From: Deborah Cullen
Sent: Monday, February 05, 2018 2:18 PM
To: Lauren Ramezani
Cc: Teresa Takaoka; Elias Sassoon
Subject: RE: IMAC, Landslide Feasibility Study

Questions on Figure 13 of the Landslide Feasibility Study

**Questions Following Up to the Rancho Palos Verdes City Council Meeting of
1/16/18 Re: Draft Portuguese Bend Landslide Feasibility Study**

Feasibility Study Figure 13 is labeled “**Modeled** Increase in Factor of Safety with Decline of Groundwater elevation.” (bold emphasis added.)

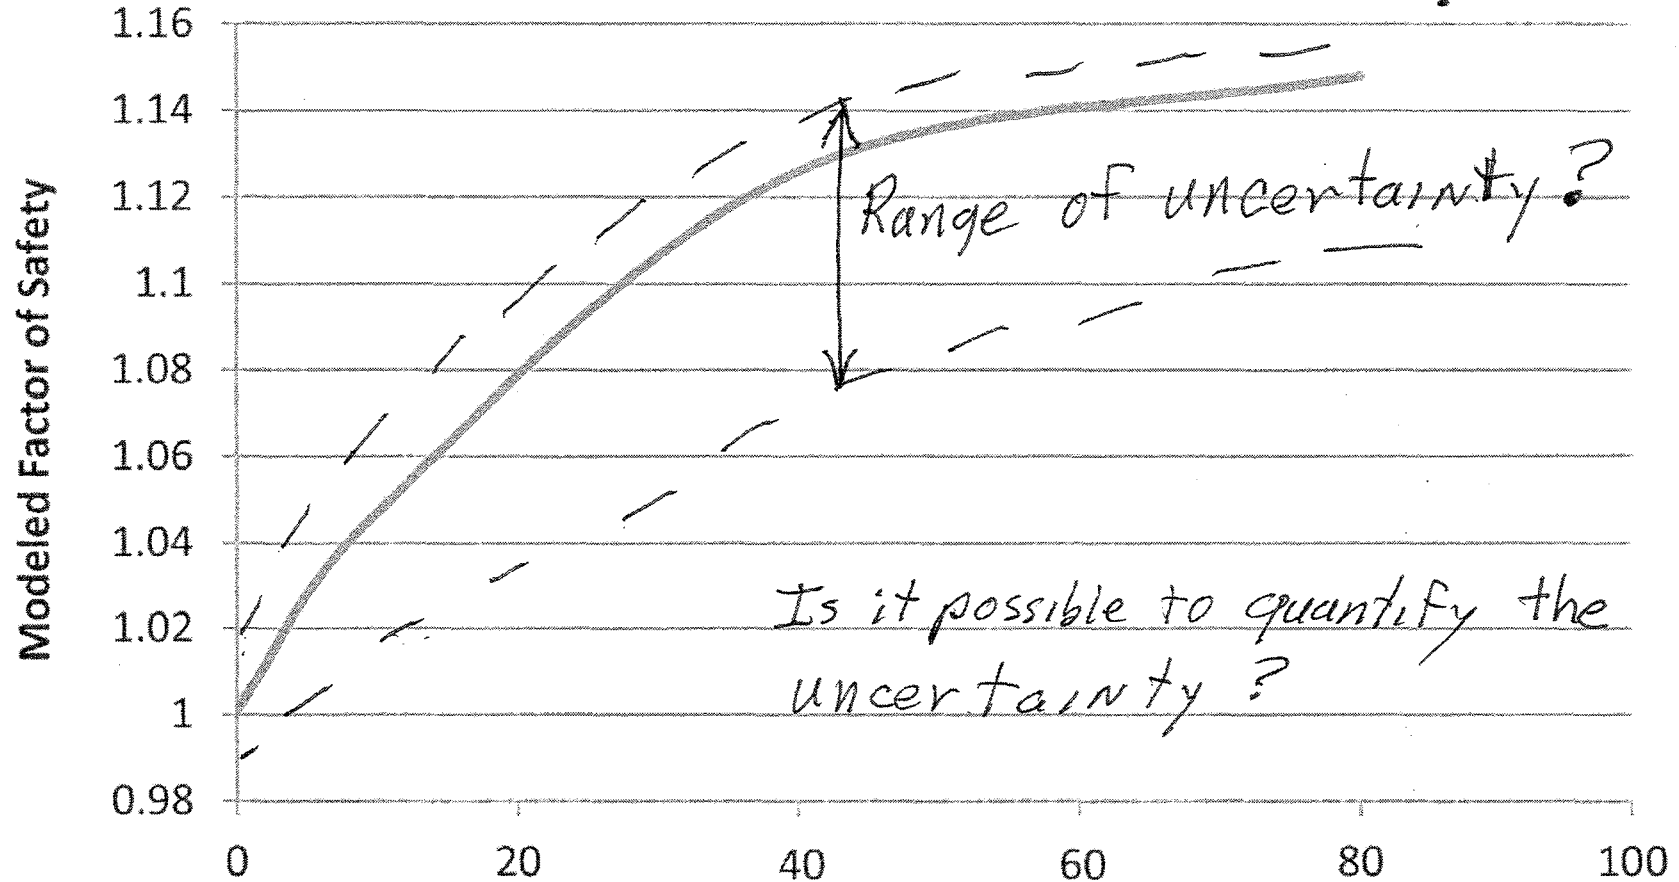
Figure 13 depicts with remarkable, mathematical precision a calculated curve that relates (A) increase in Factor of Safety to (B) reduction in groundwater elevation.

If and to the extent that the calculated curve in Figure 13 is scientifically uncertain (or incorrect), then the conclusions in the Feasibility Study are uncertain (or incorrect)

Therefore, it would be useful to modify Figure 13 to depict a scientifically calculated range of uncertainty in the plotted curve. This will reduce the potential for readers to misinterpret apparent, but scientifically unwarranted, precision in the plotted curve in Figure 13.

The appended modifications of Figure 13 suggest a way to depict the mathematical and scientific uncertainties to avoid unintentionally misleading readers.

1. Is it possible to quantify the scientific uncertainty in the curve plotted in Figure 13?
2. Is Figure 13 only a conceptual “model” based upon assumptions and interpolations from sparse field measurements such that it is not even possible to quantify the scientific uncertainty of the plotted curve?
3. Are the mathematical algorithms used in the computer programs for “three-dimensional modeling of slope stability” published? Or is the underlying computer coding a trade secret so that the persons doing the modeling are prevented from calculating the mathematical precision of the source code for the computerized calculations that produced Figure 13?

What is the scientific range of uncertainty (or confidence) in these calculated results?

Or is this figure only conceptual, based upon assumptions and interpolations from sparse field measurements?
